Subject: Genesis Gas Shock Does Not Lock

Model: U-Scan Genesis

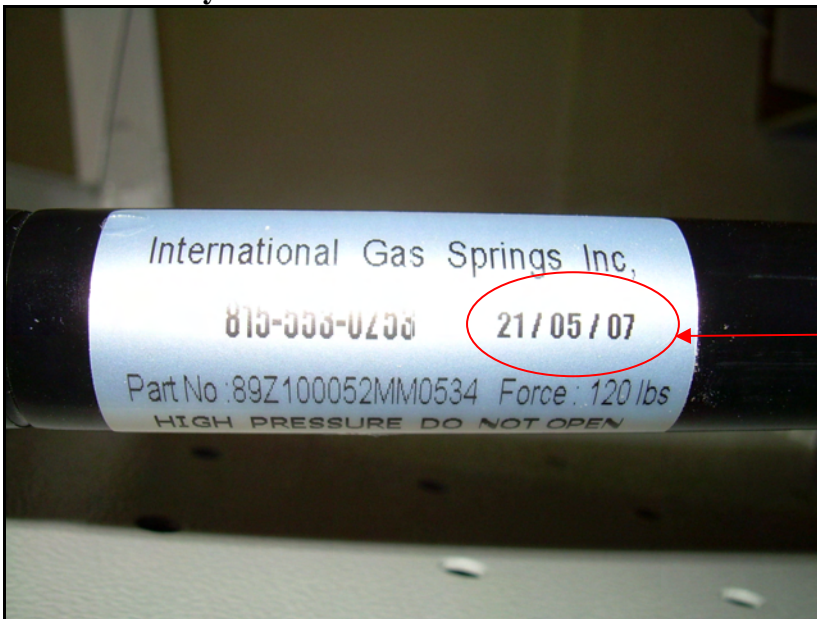
There has been some reports that the Genesis Top Door Gas Shock does not lock, The door can be closed without the lock engaging.

Any Gas Shock unit with Date Code before 05/06/08 or 19/08 should be sent back to the manufacturer for replacements under RMA#180. Shock replacements are Fit-On-Fail.
